THE LOCHS AT ABERDEEN

AN ADDITION TO WICHITA, SEDGWICK COUNTY, KANSAS

RE: SUB 2001-01 -- One- Step Final Plat of THE LOCHS AT ABERDEEN ADDITION

STAFF REPORT
(One-Step Final Plat Approved 1/25/01)

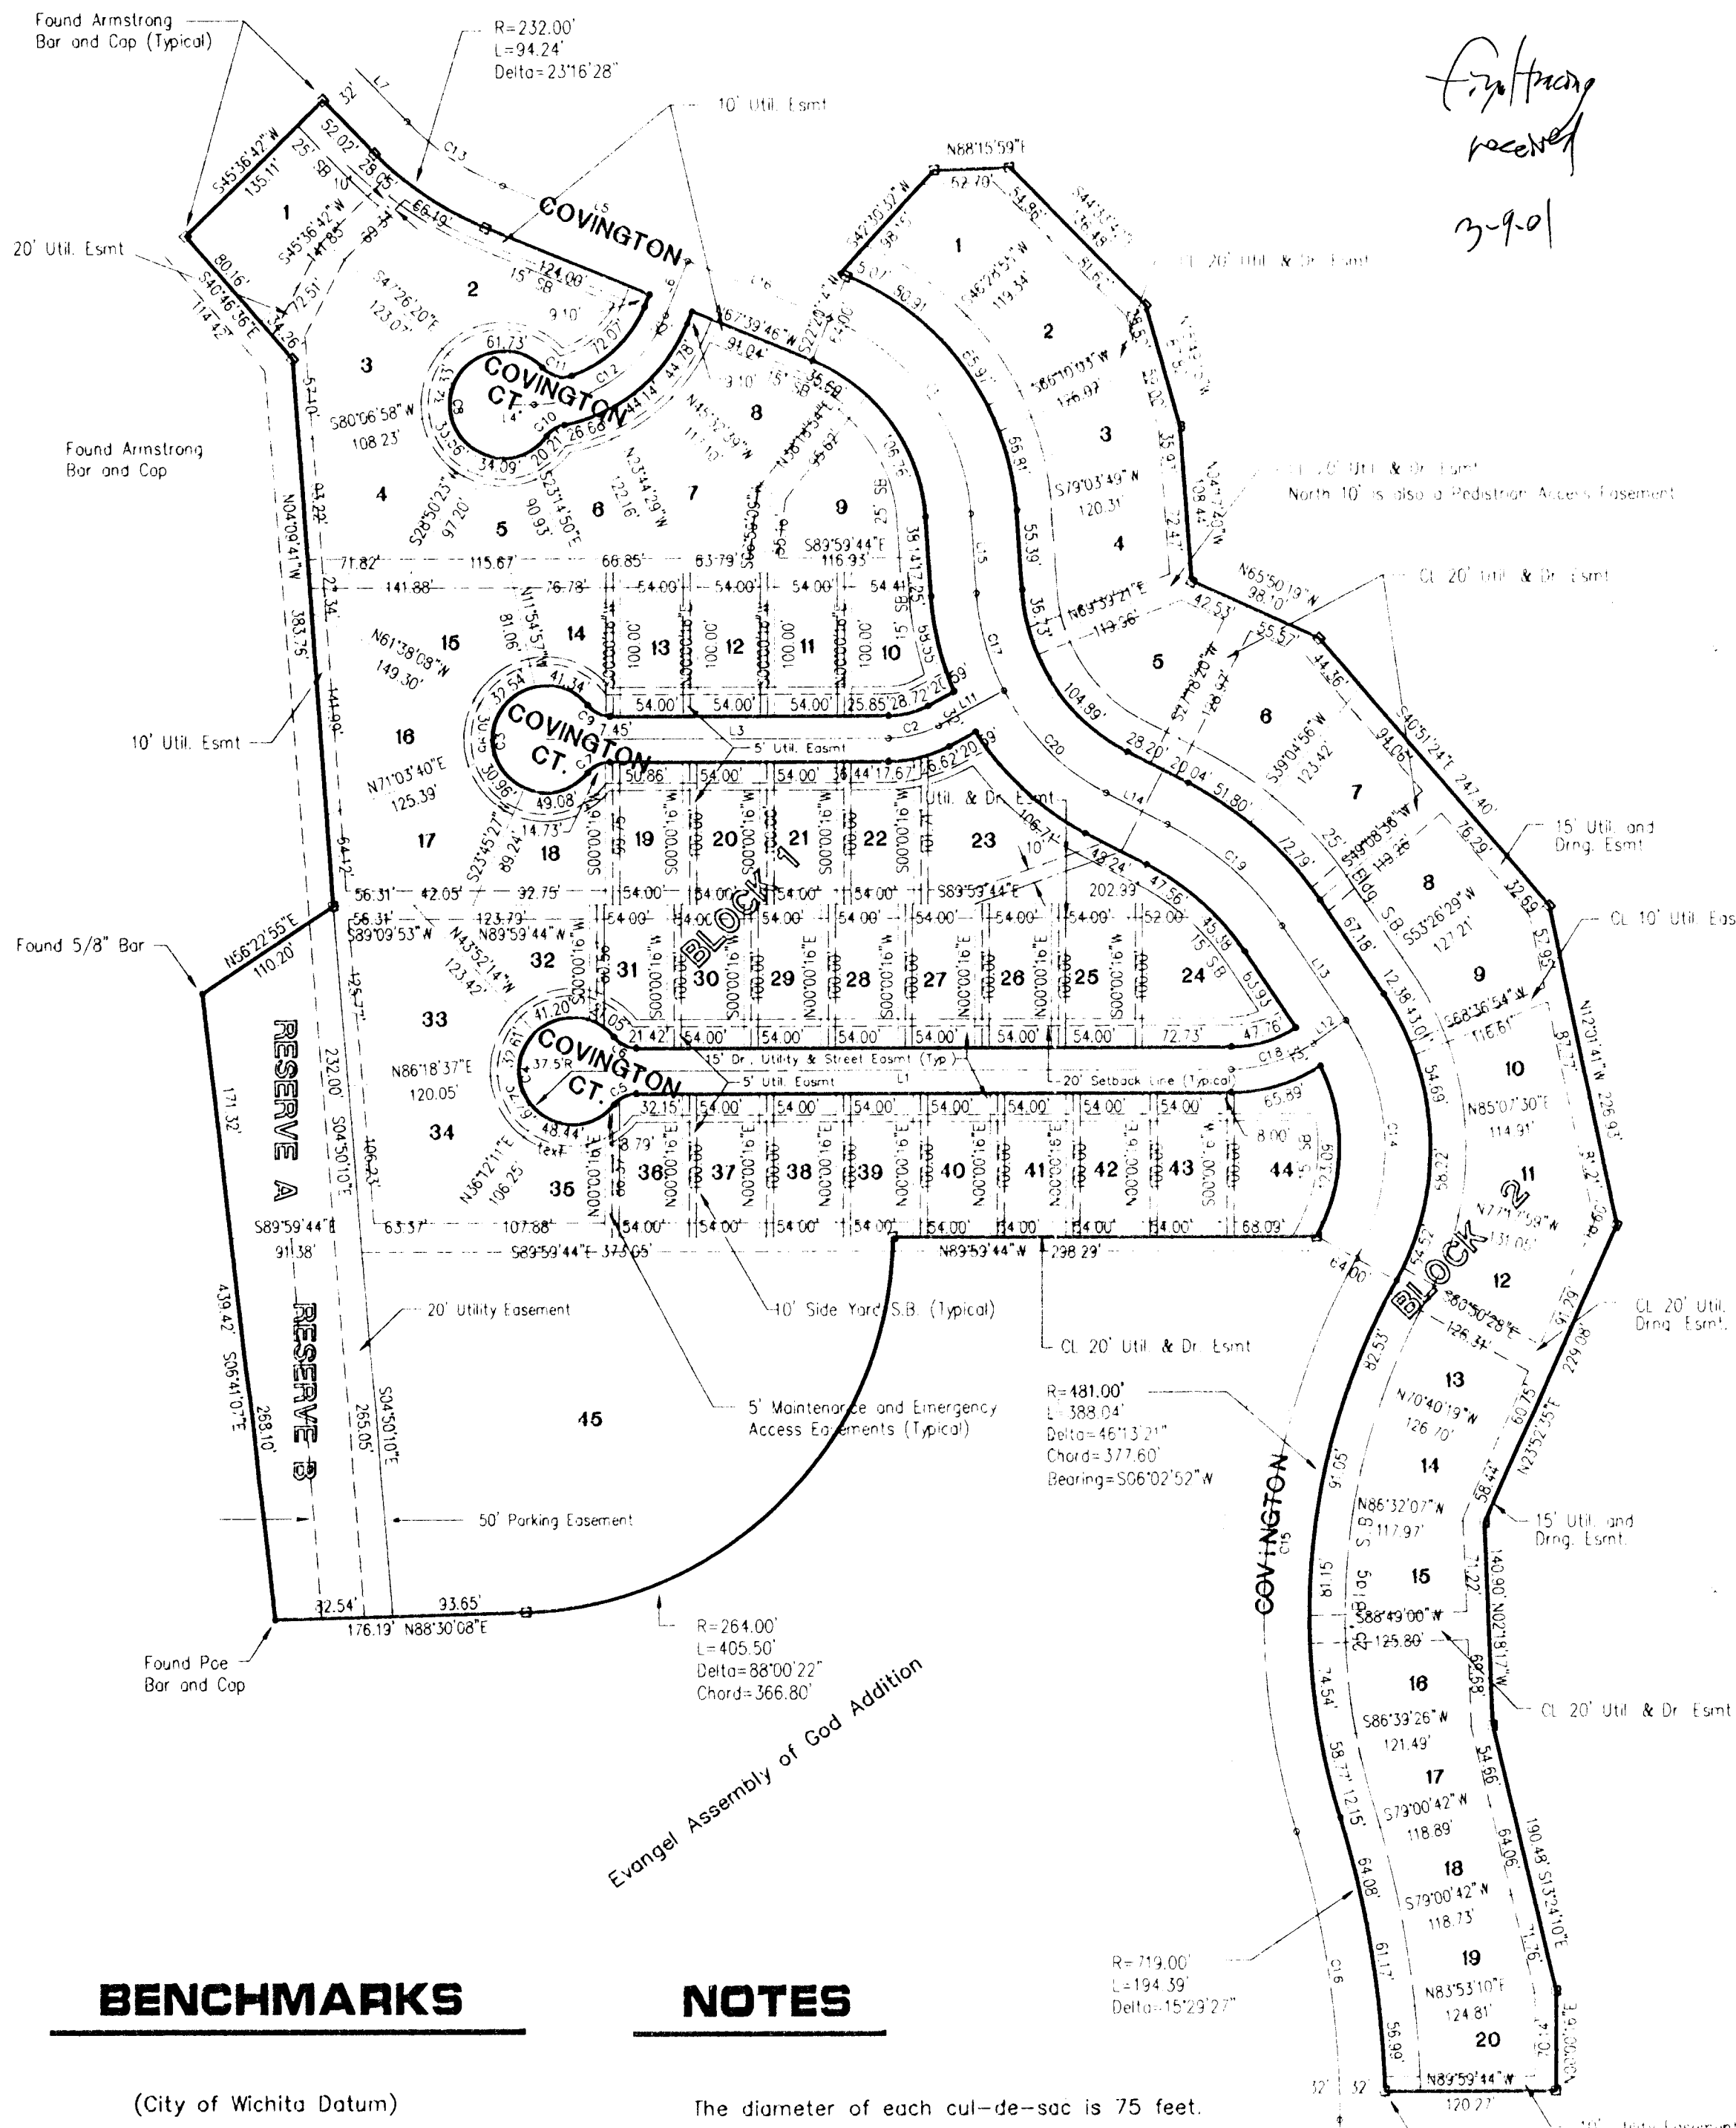
- F. The parking areas intended for Reserves A and B shall be shown on the plat as "parking easements". The easements need to be at least 20-feet deep and no wider than 50 feet. The plat's text shall also reference the platting of these easements.

- G. Because of the landlocked nature of Reserves A and B, a means of access should be provided.
- H. The applicant shall submit a covenant which provides for four (4) off-street parking spaces per dwelling unit on each lot which abuts a 32-foot street. The covenant shall inventory the affected lots by lot and block number and shall state that the covenant runs with the land and is binding on future owners and assigns.

- I. Since this plat proposes the platting of narrow street right-of-way with adjacent 15-foot street, drainage and utility easements, a restrictive covenant shall be submitted which calls out restrictions for lot owner use of these easements. Retaining walls and change of grade shall be prohibited within these easements as well as fences, earth berms and mass plantings.

- L. The MAPC Policy Statement regarding Cluster Development states that each open space area shall be a minimum of 10,000 square feet and that no lot reduced in area shall be more than 500 feet from the nearest open space area. Lots 24, 43 and 44, Block 1 are not located within the required 500 feet from Reserve A. A modification from this design standard has been approved by the Subdivision Committee.

- Q. Lot 7, Block 1, exceeds the maximum lot width to lot depth ratio of 2.5 to 1. *A modification has been approved by the Subdivision Committee.*
- R. The plat does not meet the minimum standards adopted by the Kansas State Board of Technical Professions (Regulation #66-12-1, K.S.A. 74-7037): Plat or Certificate of Survey, item #3, #4, #5, #6, and #10.

- T. The 15-ft drainage and utility easements adjacent to the 32-ft rights-of-way need to also be labeled as street easements.
- U. Lots 19, 24, and 44, Block 1, have missing dimensions.

- V. The easements on Reserves A and B need to be labeled.
- W. The legal description needs to be revised as follows: Line 2, (N89',44"W) needs changed to (S89°59'44"E). Line 10 (N44°23'18" E) needs changed to (N 44°23'18"W). Line 16 (being north of) needs changed to (being west of).
